From: [Kemp, Steve](#)
To: [McLarty, Cody](#)
Subject: ODMB Trip Report for 1-14-21
Date: Monday, January 25, 2021 2:18:28 PM
Attachments: [Site visit and conversation record 1-14-2021.msg](#)
[ODMB EQMS 8a TO 68HE0720D0007 - site visit 1-14-21.msg](#)

From: [Kemp, Steve](#)
To: [Jon Huthsing](#)
Cc: [Richard Clapp](#); [Oliver Cabrera](#); [Campbell, Todd](#); [Blackburn, LizI](#); [Fritz, Koni](#)
Subject: Site visit and conversation record 1-14-2021
Date: Friday, January 15, 2021 7:33:00 AM

From: [Kemp, Steve](#)
To: [Jason Smith](#); [Barry Appleton](#); [Bryer Smith](#)
Cc: [Craig Hoby](#); [Fritz, Koni](#); [Campbell, Todd](#); [Blackburn, Liz](#); [Hagenmaier, Elizabeth](#)
Subject: ODMB EQMS 8a TO 68HE0720D0007 - site visit 1-14-21
Date: Wednesday, January 20, 2021 9:03:00 AM
Attachments: [EPA Revisions to the design of the Kevin Southard south property 112219.pdf](#)

EAST 17TH STREET REPOSITORY

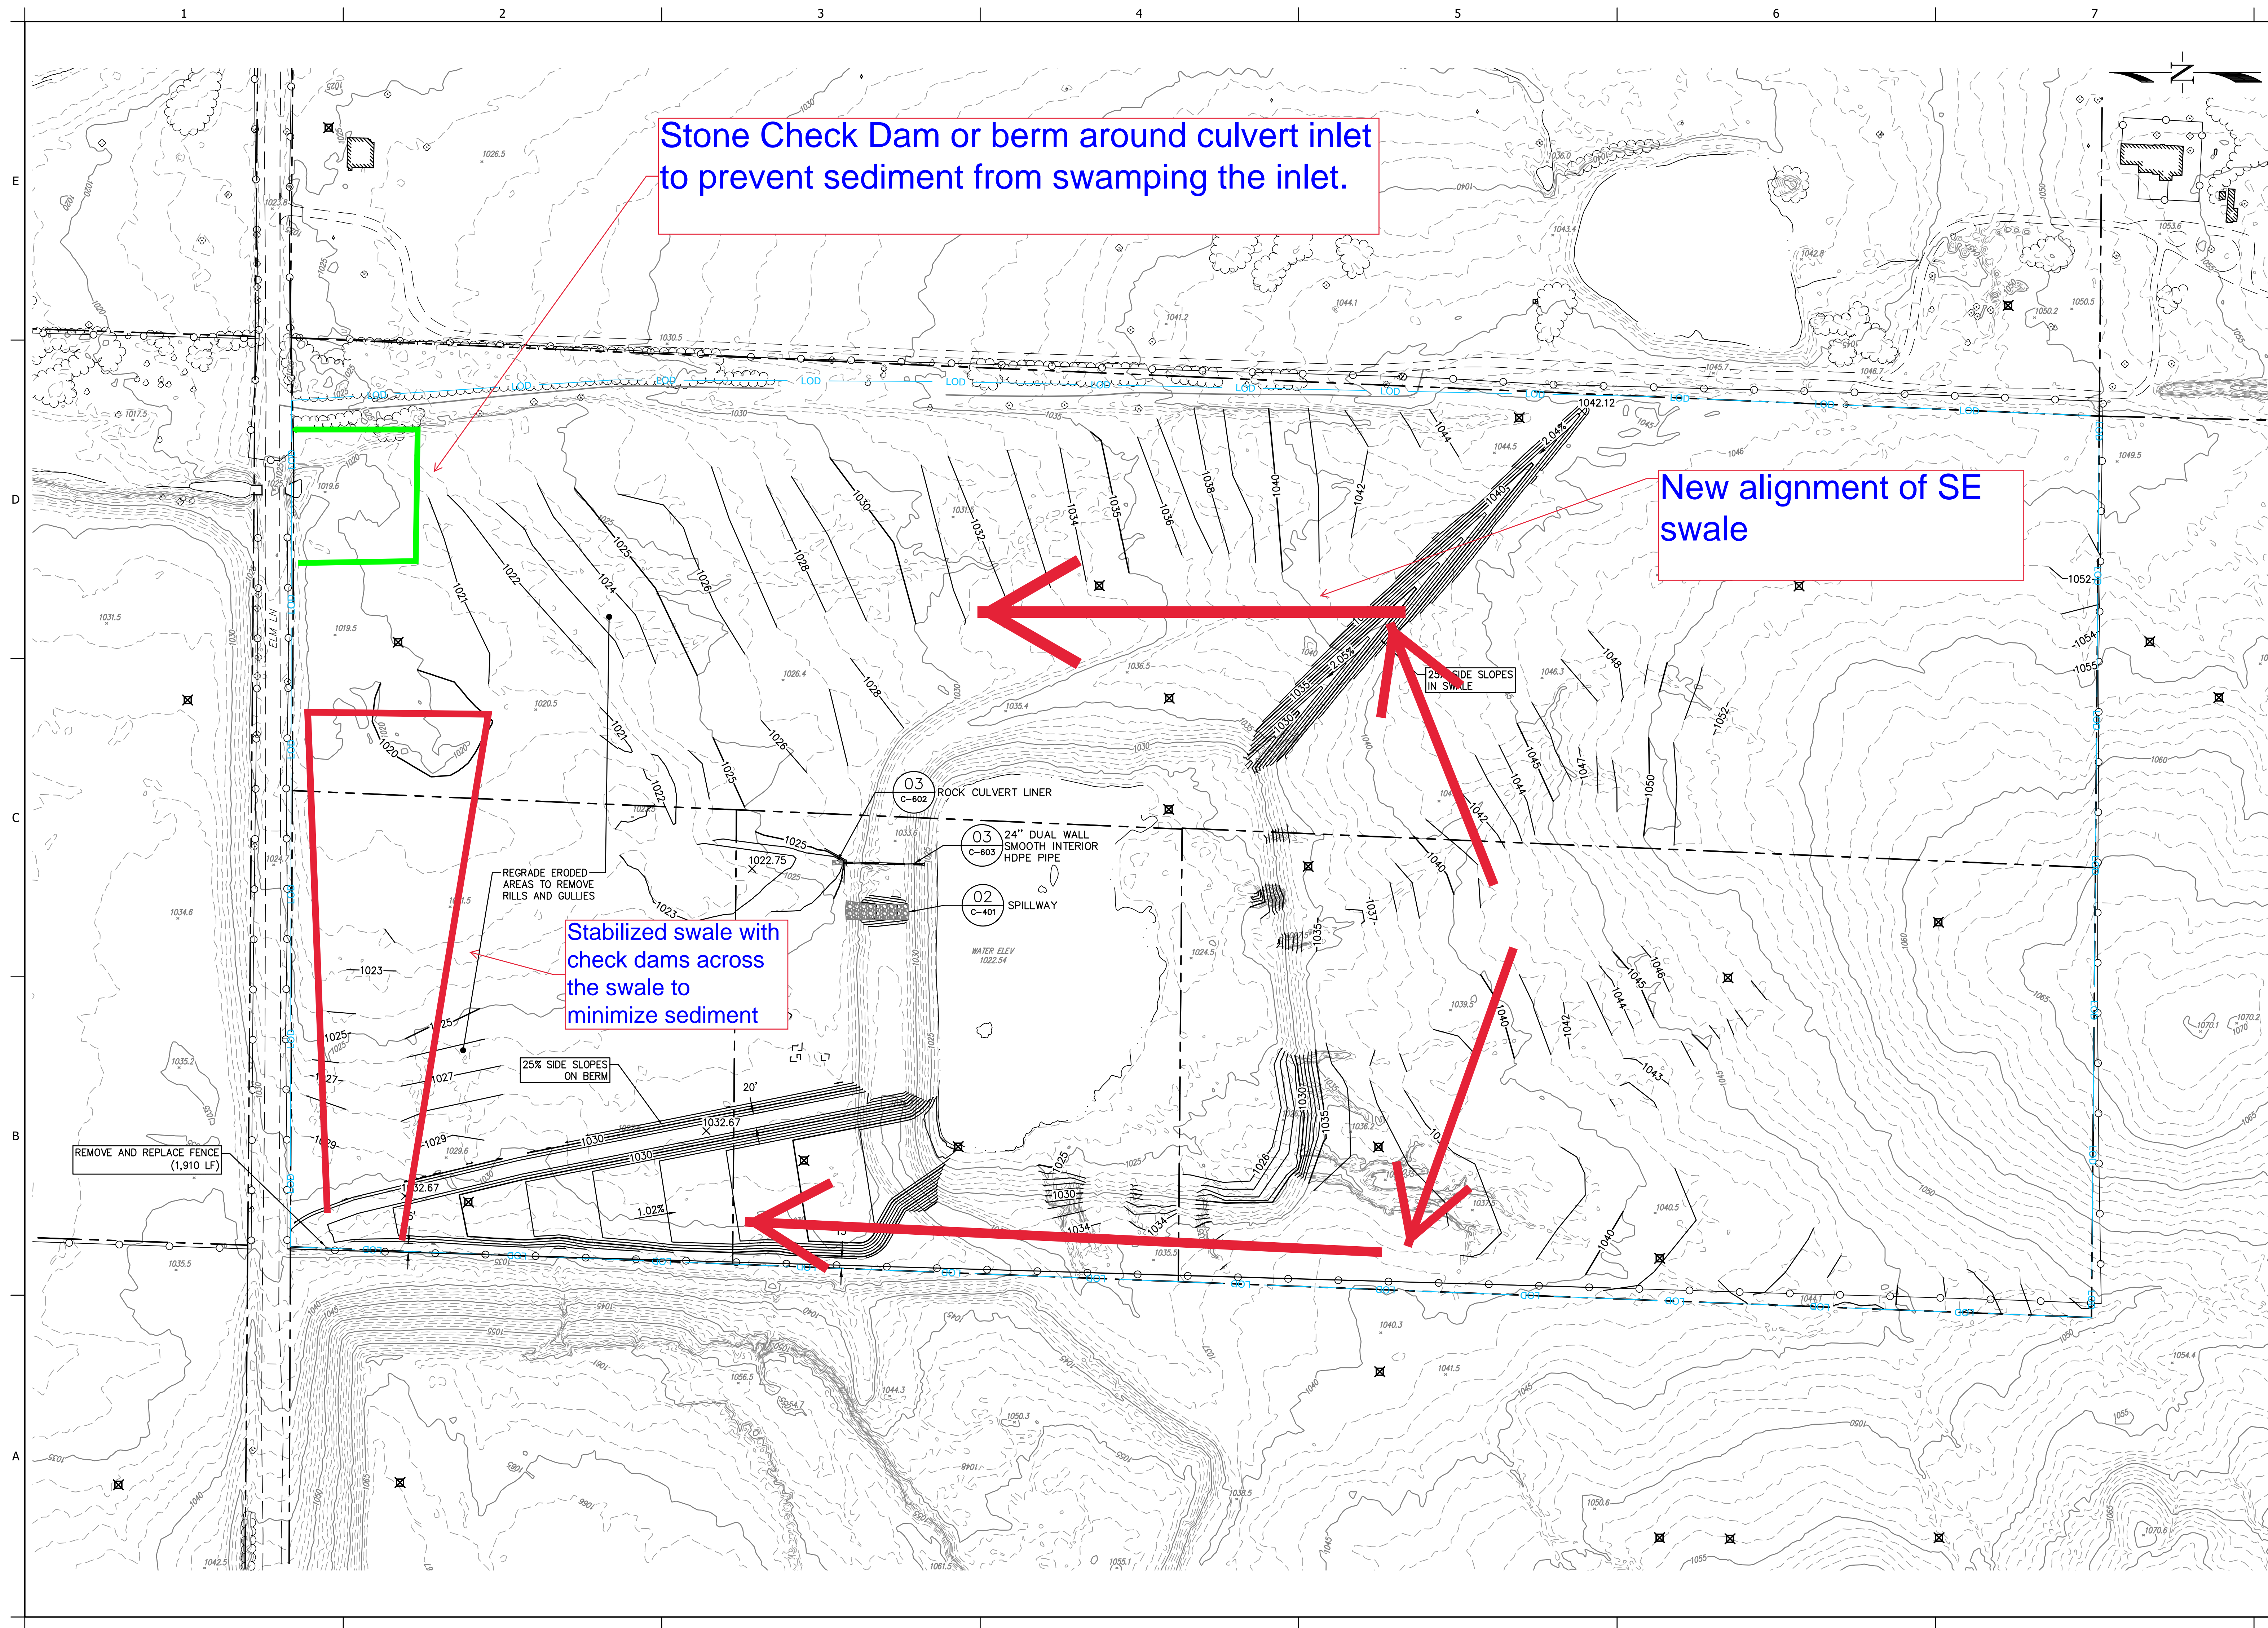
2. We discussed the changes that Mr. Southard requested during a previous site visit this past summer. Although, I sent the map depicting the changes to Mr. Southard a few months back he had not seen the map (attached). Mr. Southard is generally ok with the revisions depicted on the attached sketch. He agreed that EQMS may divert stormwater runoff to the existing retention basin in the short term, with the understanding that EPA will fill the retention basin with mine waste and complete the basin as an additional small repository as part of a subsequent contract. Mr. Southard confirmed my understanding from the previous meeting that he prefers the stabilized swale run from west to east along the north end of his property. Mr. Southard also requested that the top of the berm around the current retention basin be cut down 4-5 feet at the time the small repository is completed and I agreed.
